CITY PLAN COMMISSION STAFF REPORT

CD-CPC-2026-00042

Hohl Farm

Development Plan

SHEET NAME
COVER SHEET & SITE PLAN
SHEET NO.

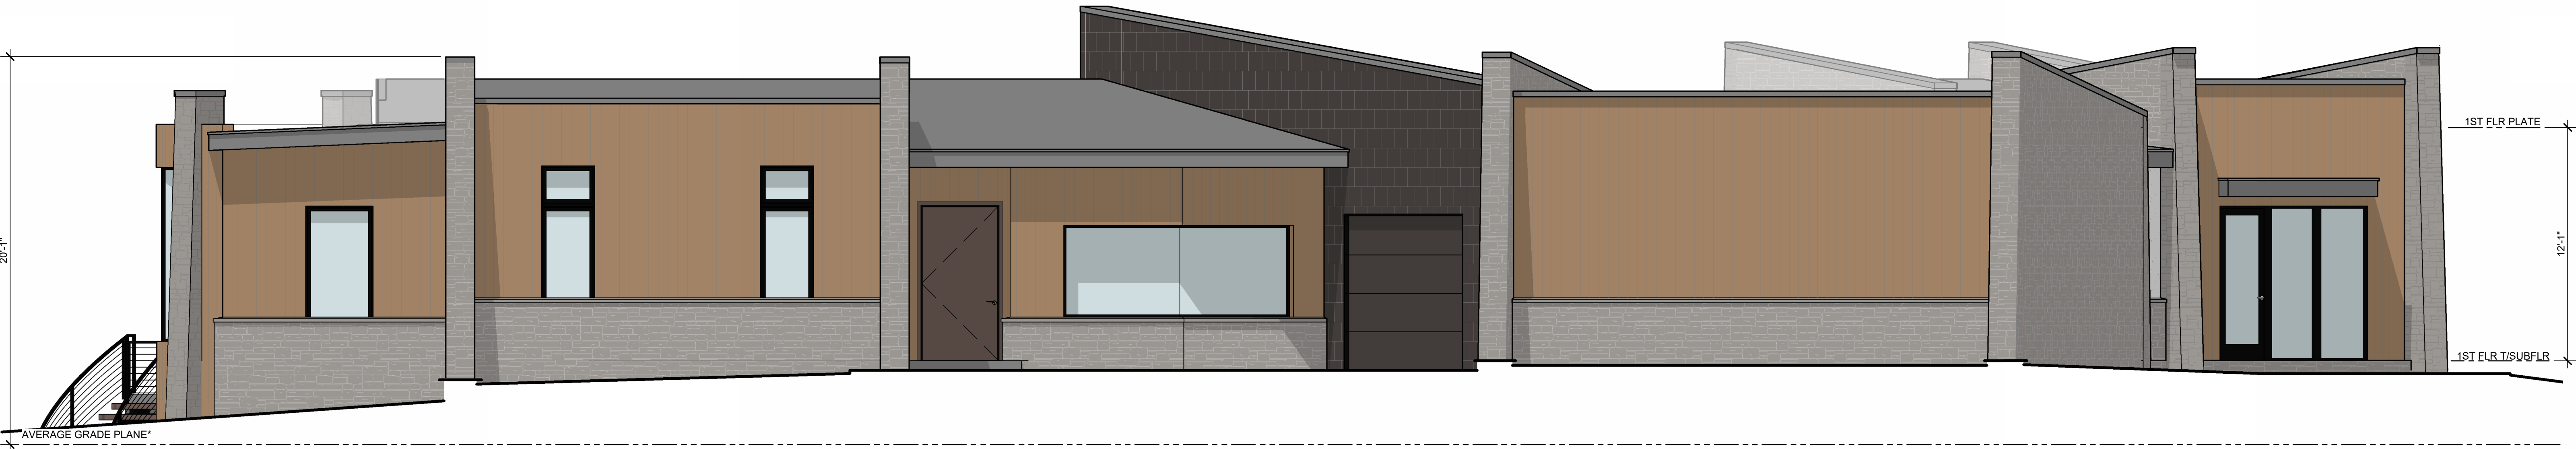
The proposed plan complies with the standards of the Zoning and Development Code except for the accessory structure standards. The proposed greenhouse is in front of the existing principal structure, thus encroaching onto the front yard. Staff included a condition to have the applicant revise the site plan to move the greenhouse back to be either behind or aligned with the front wall of the existing principal building.

3. The applicant shall revise and resubmit the site plan showing the greenhouse to be behind the existing houses prior to ordinance request. (5/14/2026)

SHEET NAME
UTILITY PLAN

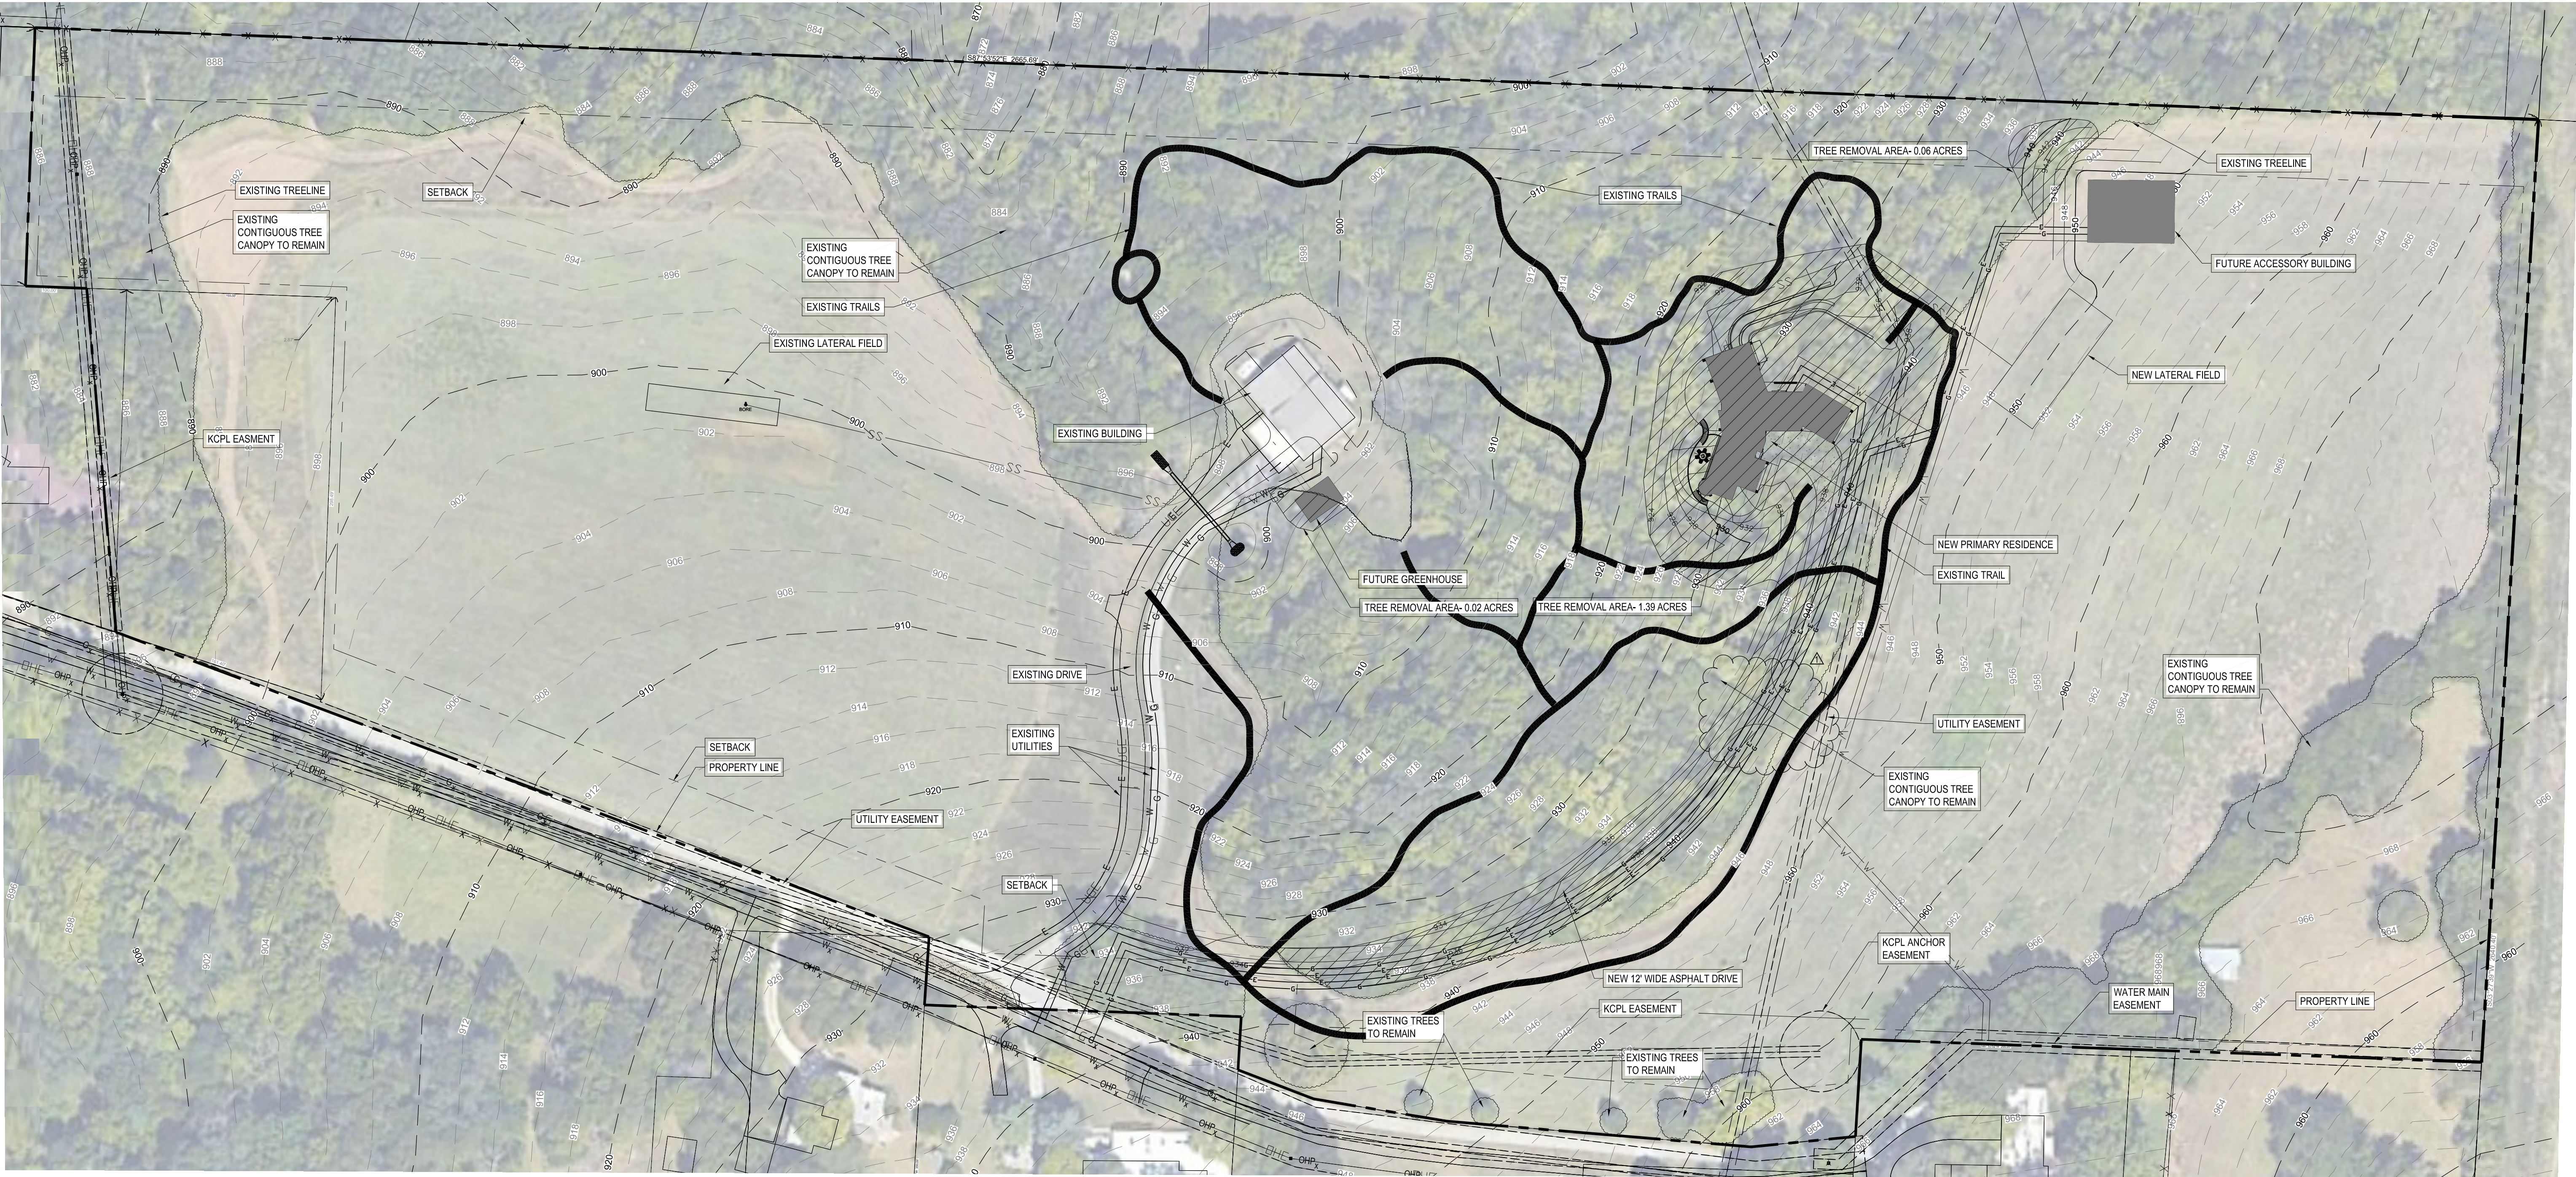
12. The existing water main along Blue River Road is only a 2" diameter main according to our GIS maps. It is likely the 8" DIP water main to the south will need to be extended north to provide adequate flow and pressure for the new fire and domestic demands. If after confirming existing flow and pressure vs. proposed demands a larger main is needed, then the developer shall submit water main extension plans prepared by a Missouri PE for review and permitting through CompassKC. The plans shall be under contract (permit) prior to building permit issuance or final plat recording whichever occurs first. (4/09/2026)

SHEET NAME
TREE REMOVAL AND
LANDSCAPE PLAN
SHEET NO.
L1.00

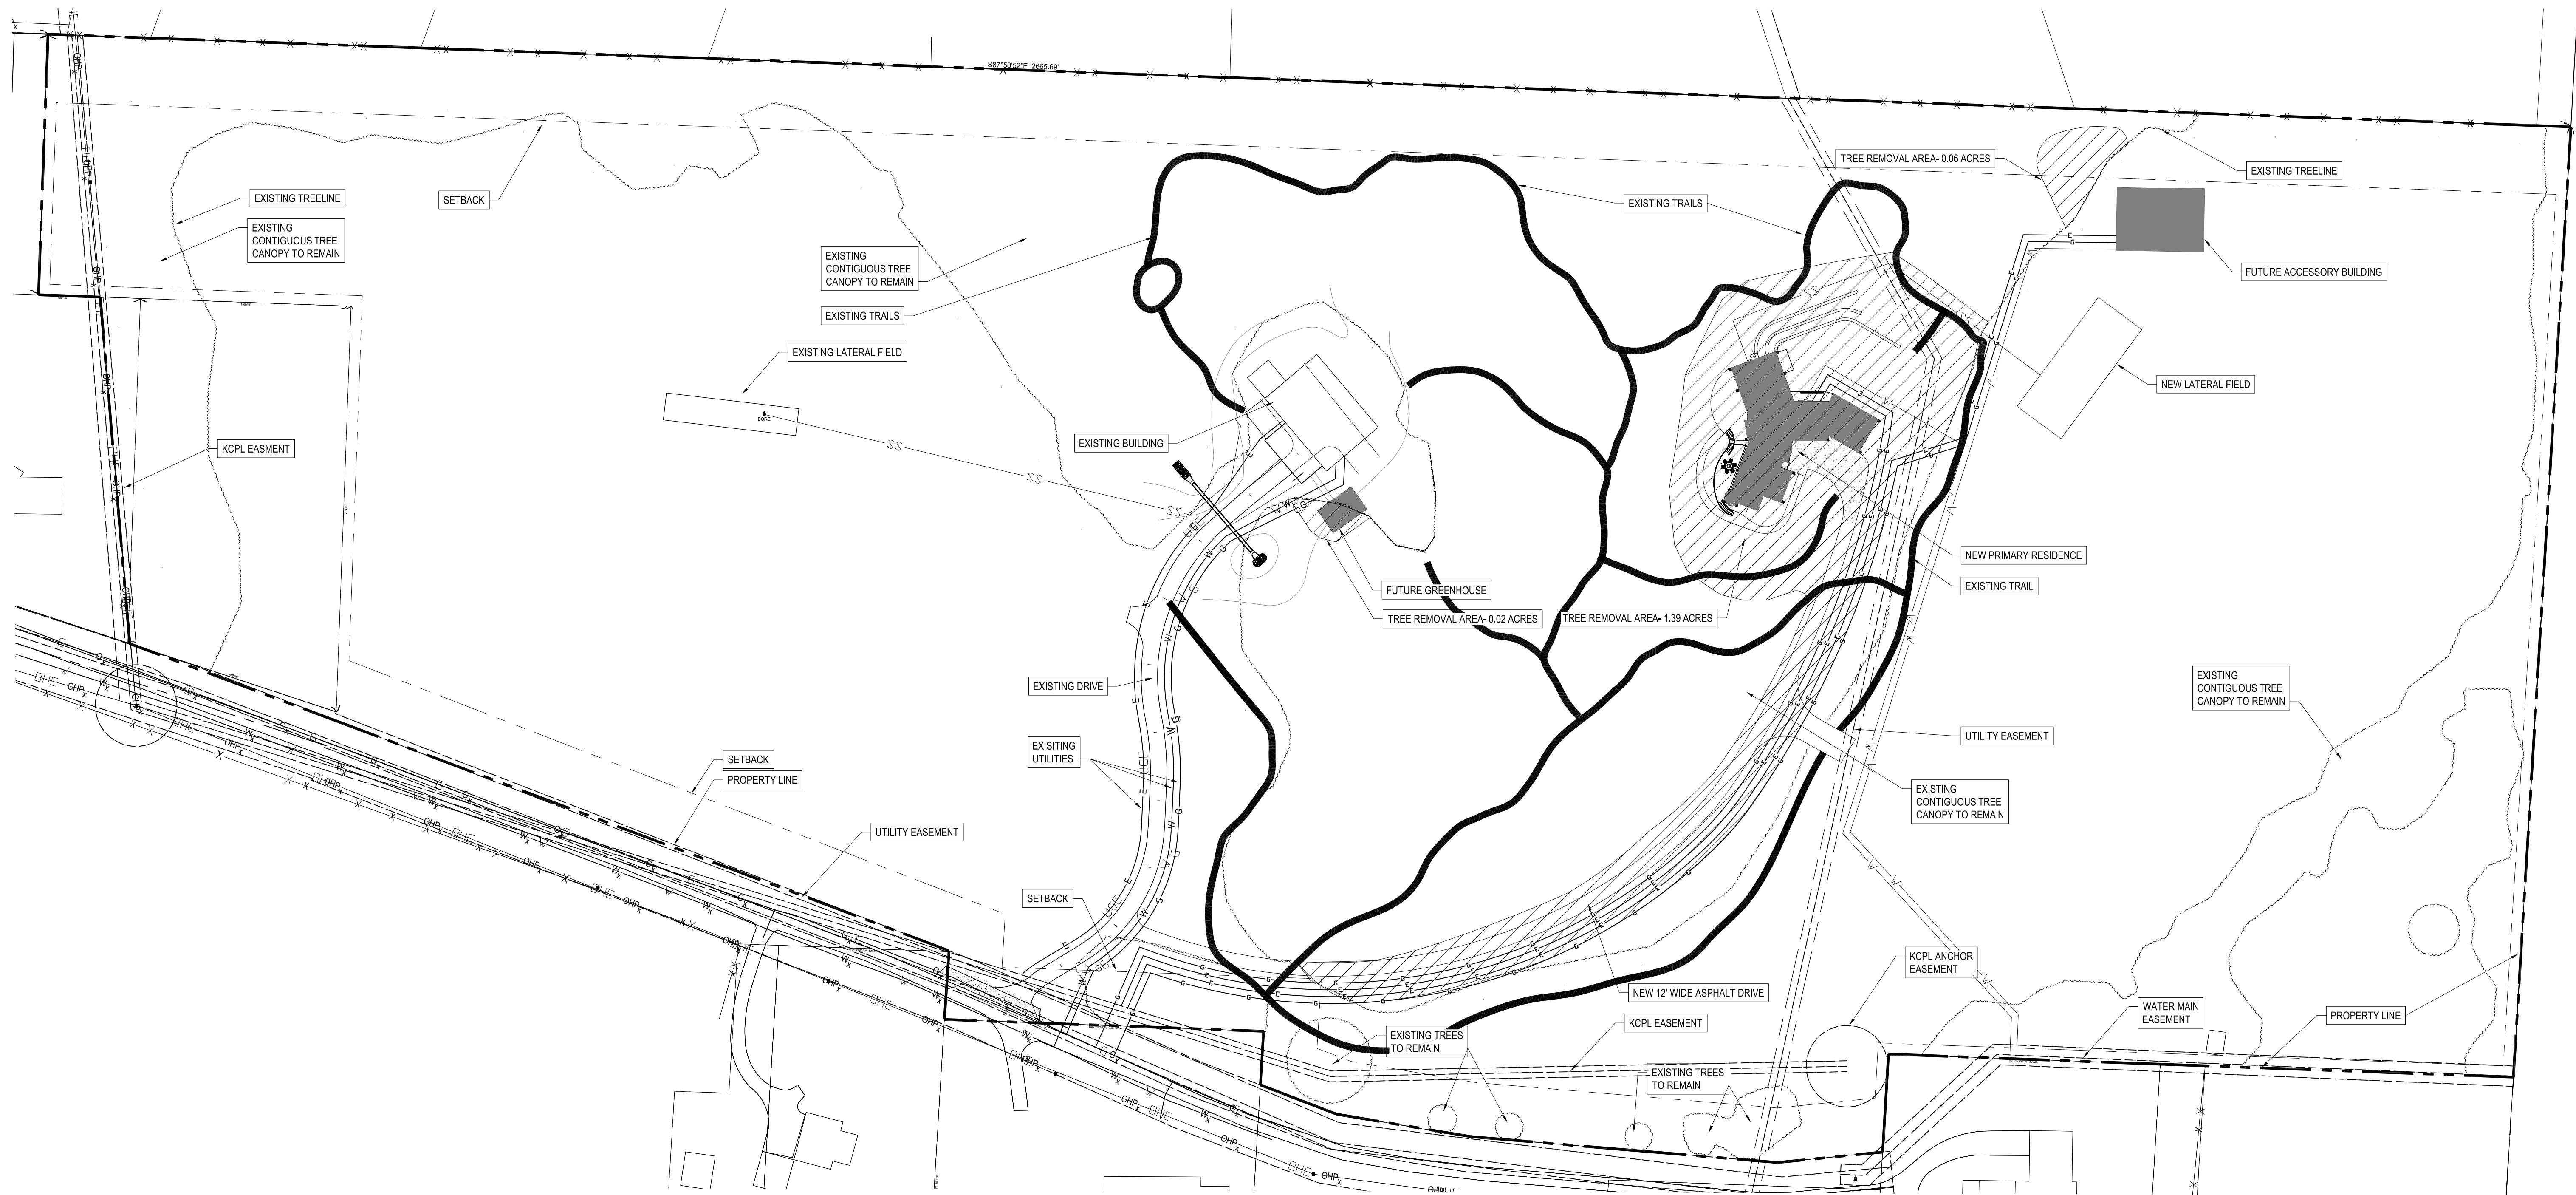
The applicant submitted a tree preservation and mitigation plan; the plan shows no mitigation is required. The site currently hosts 8.57 acres of tree canopy. A total of 1.47 acres of tree canopy will be removed for the construction of the new house, new driveway, and green house, but 7.10 acres of tree canopy are to remain.
